Re: Docket No. 461A - CSC 461A Greenwich Substation and Line Project - Petition for Reconsideration

Response to CSC-01 Interrogatories dated 06/12/2017

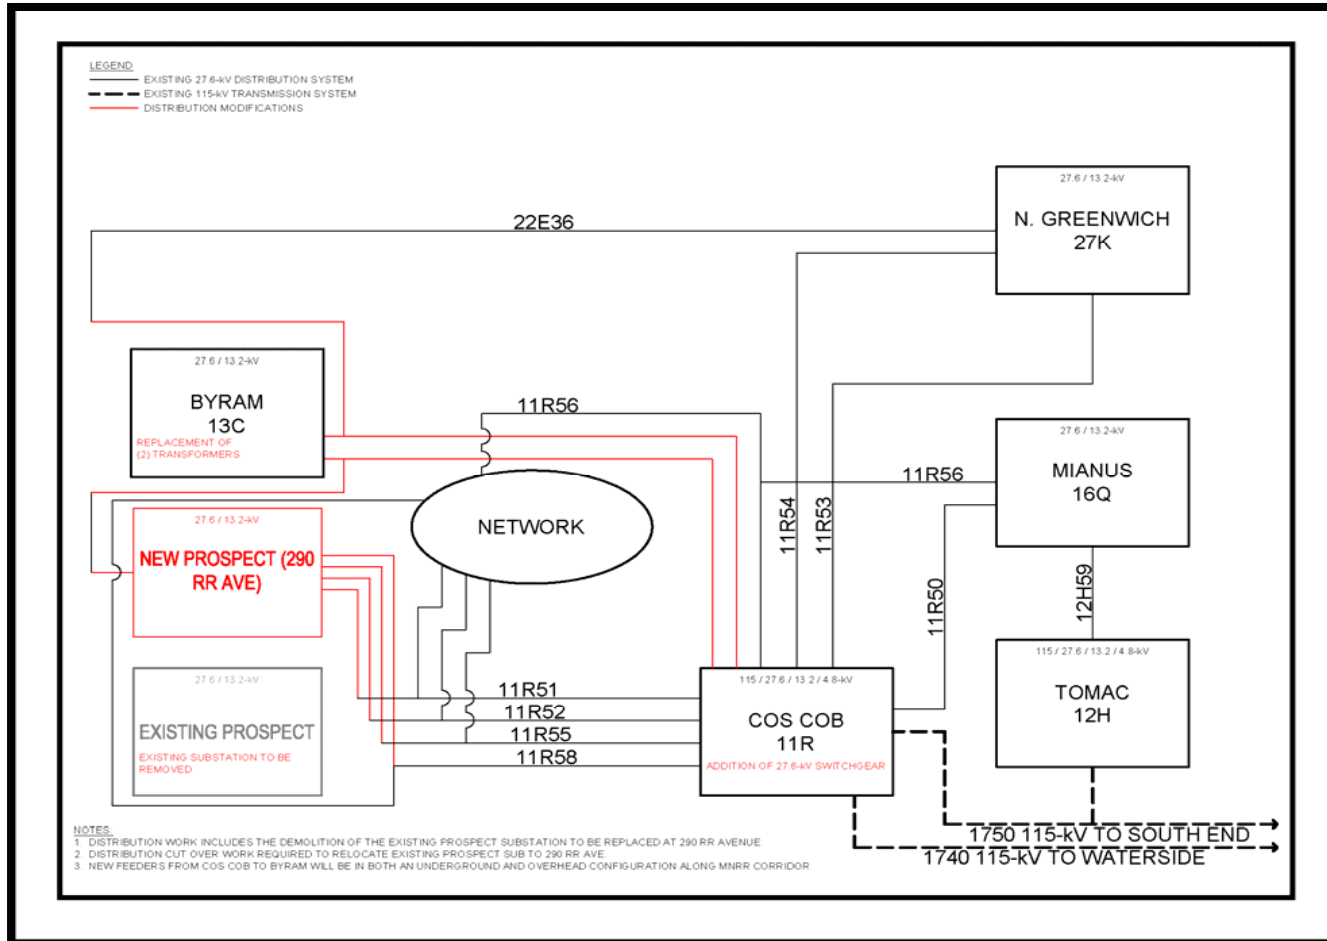
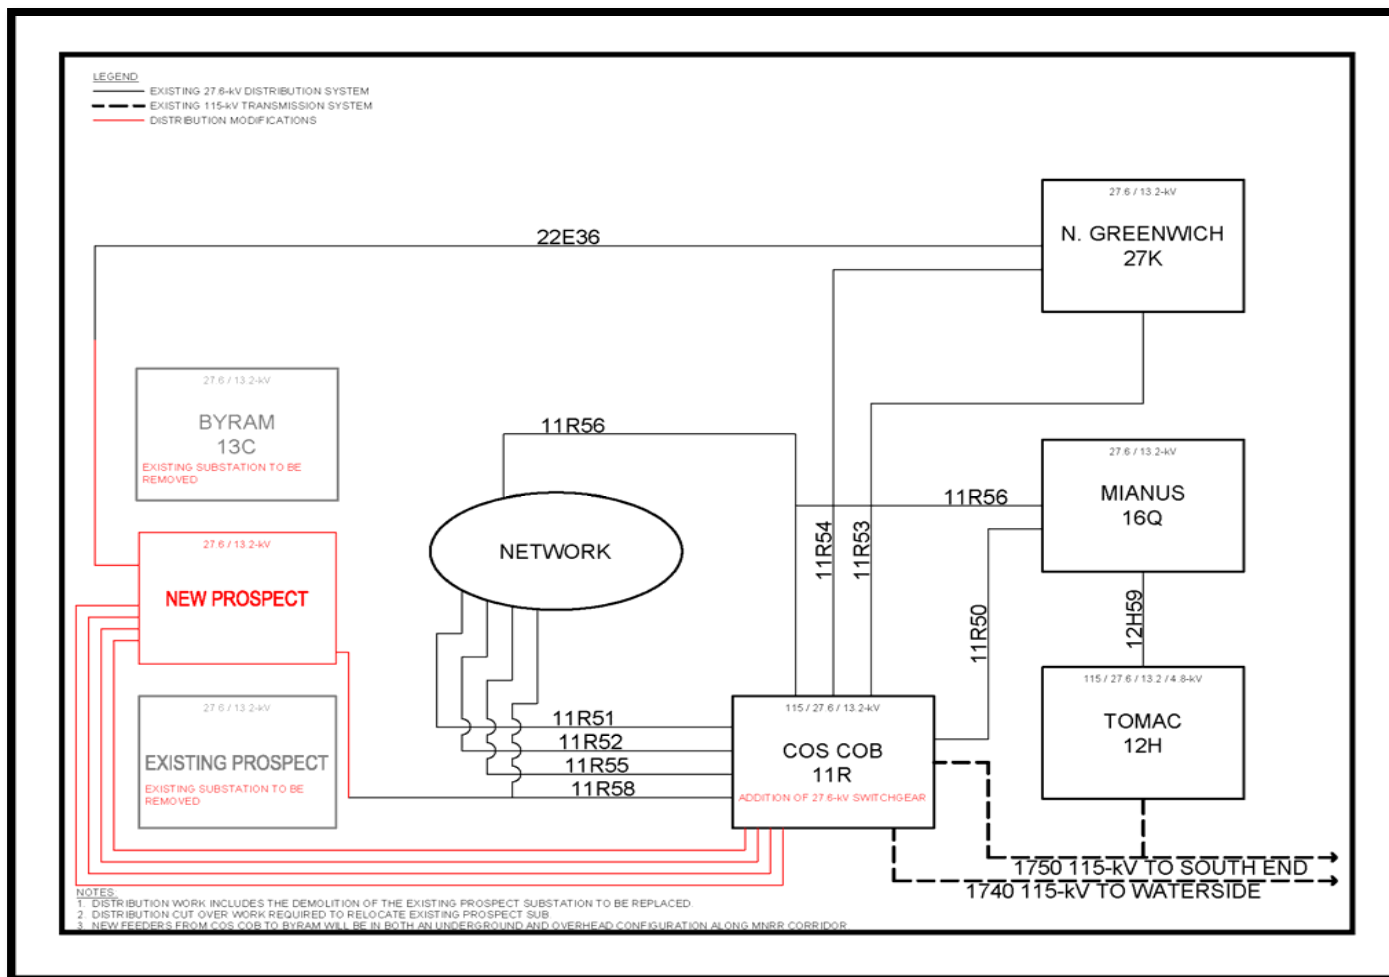
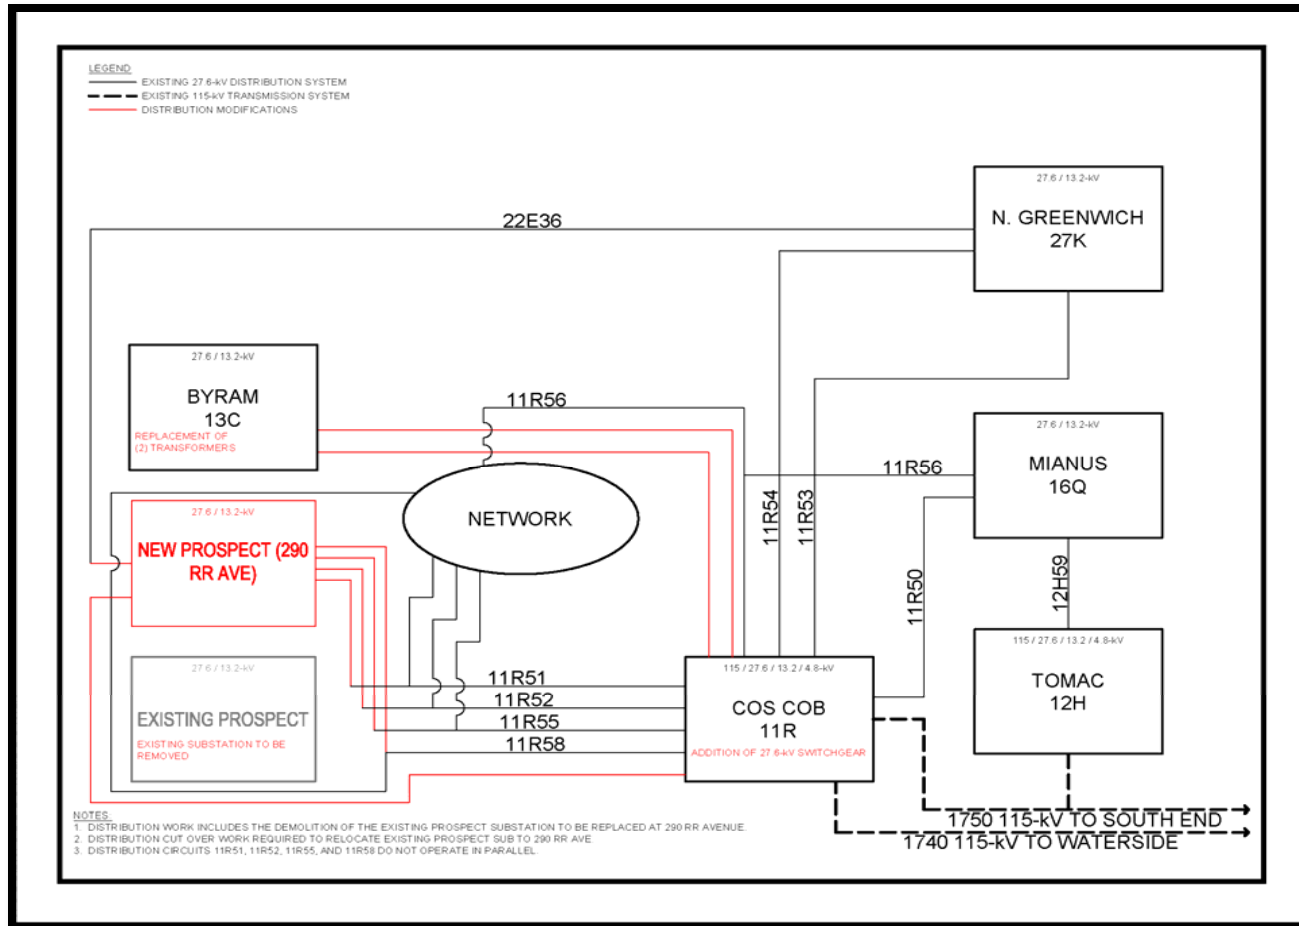
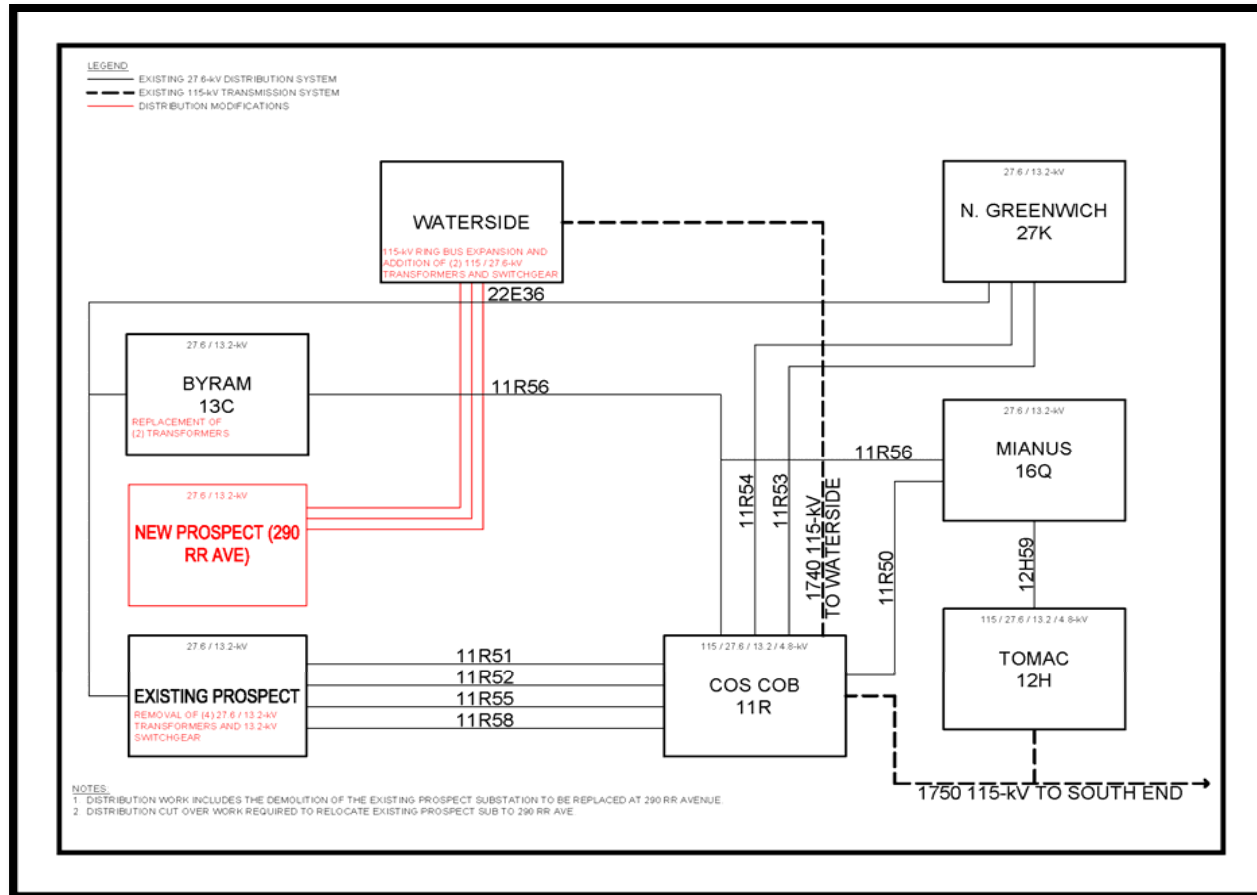
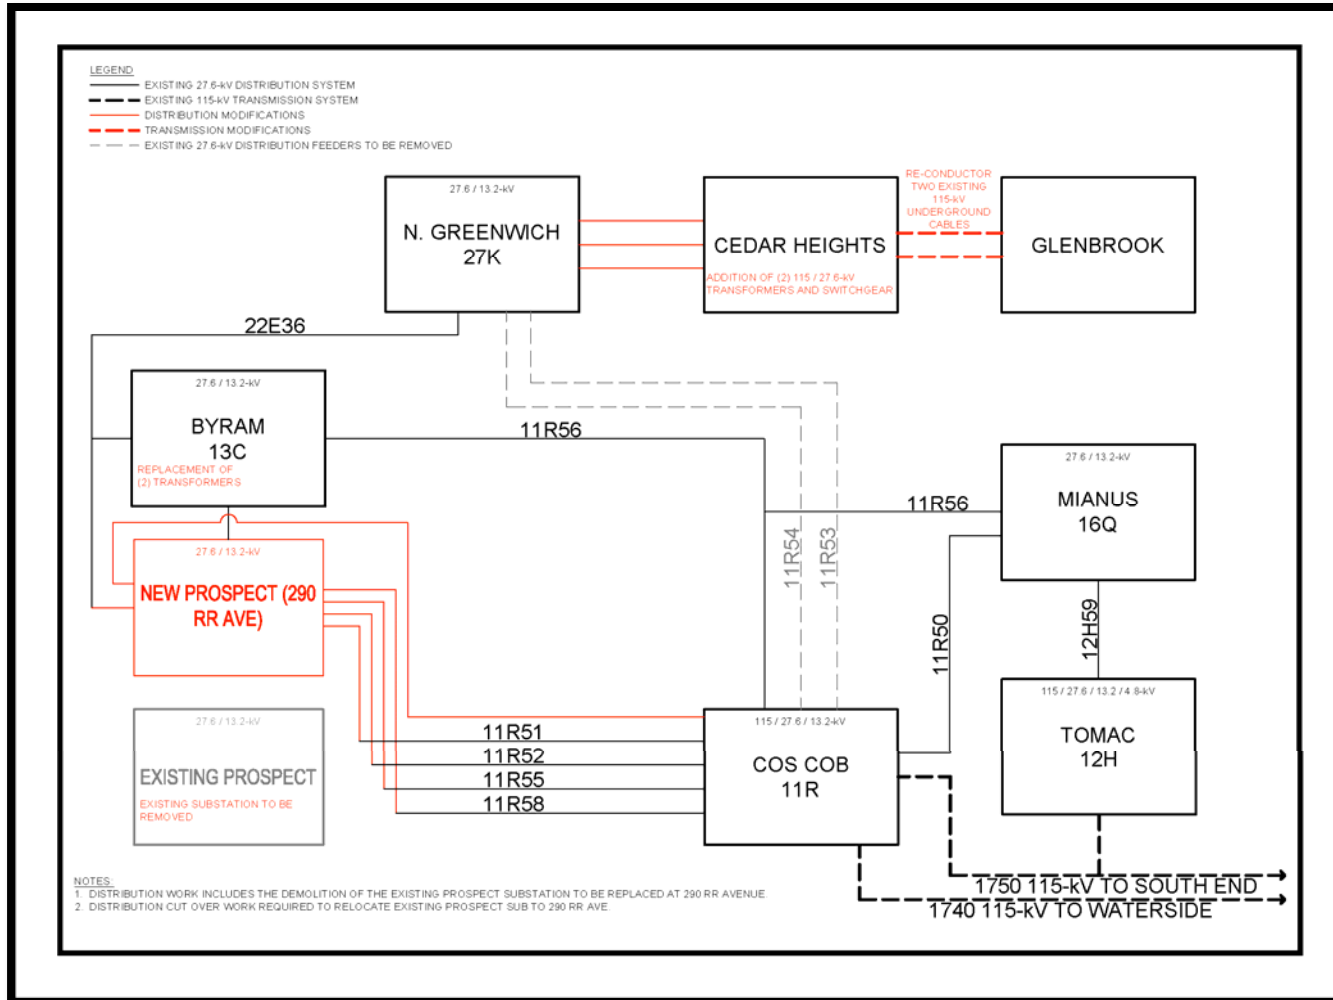
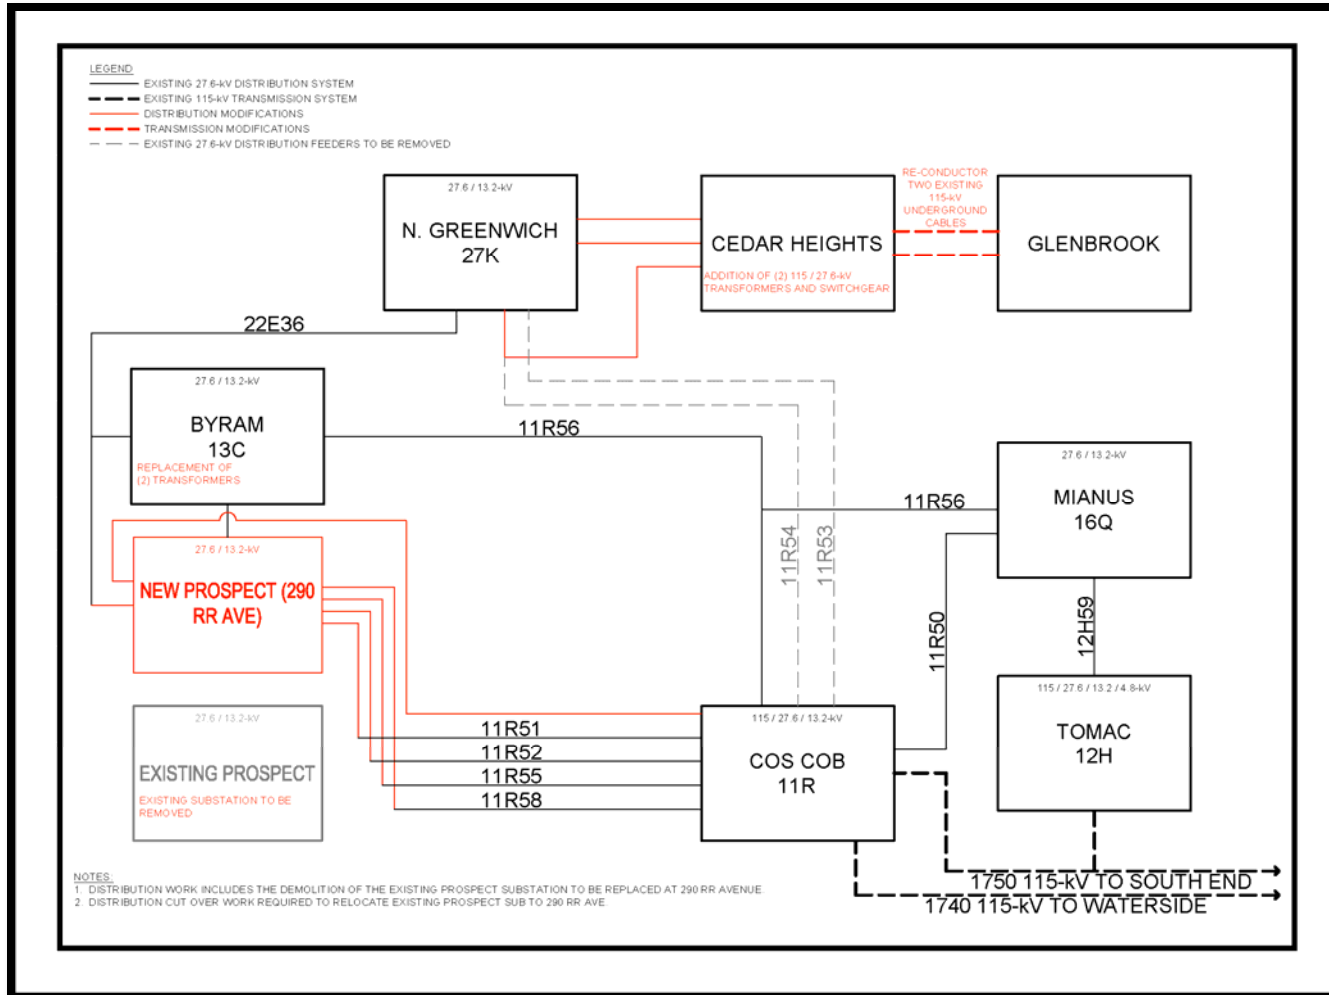
Reference Reopened Application Vol. 1, Pre-filed Testimony p. 17, Line 526. Provide design and associated costs for each of the eight distribution alternatives that were examined and ultimately rejected.

The attached pdf "IR 26 Distribution Alternatives Cost_Description" provides a description of each of the eight distribution alternatives along with their associated conceptual costs. Also attached are conceptual one line diagrams for options 3 through 7A.

Distribution Option 3: Two Feeders from Cos Cob to Byram & New Prospect S/S	*Install (2) 27.6-kV feeders from Cos Cob Substation to Byram Substation in an underground/overhead configuration. The overhead portion would utilize 750 AL aerial insulated cable for 3.5 miles, while the underground portion would utilize 1000 kcmil Cu conductor for 0.7 miles *Add 27.6-kV switchgear at Cos Cob Substation to accommodate new feeders. *Reconfigure existing feeders *Build new 27.6/13.2-kV Substation on Railroad Ave; Install two 80 MVA 27.6/13.2-kV transformers *Remove existing Prospect Substation *Upgrade two transformers at Byram Substation from 12.5 MVA to 25 MVA.	*This configuration does not avoid loss of load in the event of loss of two or more transformers at Cos Cob. The loss of load in that event could be up to 92% of the Cos Cob 27.6 kV system *In addition, in order to reconfigure the 27.6 kV design at Cos Cob, a new bulk substation is needed	\$102M

Distribution Option 5: Two Feeders from Cos Cob to Byram, One Feeder from Cos Cob to New Prospect S/S	*Install (2) 27.6-kV feeders from Cos Cob to Substation to Byram Substation and install (1) 27.6-kV feeder from Cos Cob Substation to New Prospect Substation in an underground configuration utilizing 1000 kcmil Cu conductor for 4.6 miles. All feeders would utilize the same ductbank *Add 27.6-kV switchgear at Cos Cob Substation to accommodate new feeders. *Reconfigure existing feeders *Build a new 27.6/13.2-kV Substation on Railroad Ave; Install two 80 MVA 27.6/13.2-kV transformers *Remove existing Prospect *Upgrade two transformers at Byram Substation from 12.5 MVA to 25 MVA.	*This configuration does not avoid loss of load in the event of loss of two or more transformers at Cos Cob. The loss of load in that event could be up to 92% of the Cos Cob 27.6 kV system *In addition, in order to reconfigure the 27.6 kV design at Cos Cob, a new bulk substation is needed	\$109M

Distribution Option 6: Three Feeders from Waterside to New Prospect S/S	*Install (3) 27.6-kV feeders from Waterside Substation to New Prospect Substation in an underground configuration utilizing 1000 kcmil Cu conductor for 6.2 miles *Waterside Substation Modifications; expand 115-kV ring bus and add two 115/27.6-kV transformers and switchgear *Build a new 27.6/13.2-kV Substation on Railroad Ave; Install three 25 MVA 27.6/13.2-kV transformers *Remove four 27.6/13.2-kV transformers and 13.2-kV switchgear at Existing Prospect *Upgrade two transformers at Byram Substation from 12.5 MVA to 25 MVA.	*This option was dismissed for the following reasons: **Significantly higher cost compared to other alternatives **This configuration does not avoid loss of load in the event of loss of two or more transformers at Cos Cob. The loss of load in that event could be up to 39% of the Cos Cob 27.6 kV system	\$163M

Distribution Option 7: Fifth Feeder from Cos Cob to New Prospect S/S & Three Feeders from Cedar Heights to North Greenwich	*Add a fifth 27.6-kV feeder from Cos Cob Substation to New Prospect Substation in an underground configuration utilizing 1000 kcmil Cu conductor for 3.1 miles *Install (3) 27.6-kV feeders from Cedar Heights Substation to North Greenwich Substation in an underground configuration utilizing 1000 kcmil Cu conductor for 10.3 miles *Install one 115/27.6-kV transformer and switchgear at Cedar Heights Substation *Build new 27.6/13.2-kV Substation on Railroad Ave; Install three 25 MVA 27.6/13.2-kV transformers *Remove existing Prospect Substation *Upgrade two transformers at Byram Substation from 12.5 MVA to 25 MVA *Rebuild two 115-kV circuits from Cedar Heights Substation to Glenbrook Substation in an underground configuration utilizing 1000 kcmil Cu conductor for 4.9 miles	*This option was dismissed for the following reasons: **Significantly higher cost compared to other alternatives **This configuration does not avoid loss of load in the event of loss of two or more transformers at Cos Cob. The loss of load in that event could be up to 38% of the Cos Cob 27.6 kV system ** Community impact, which includes acquiring multiple easements, expansion of Cedar Heights Substation	\$303M
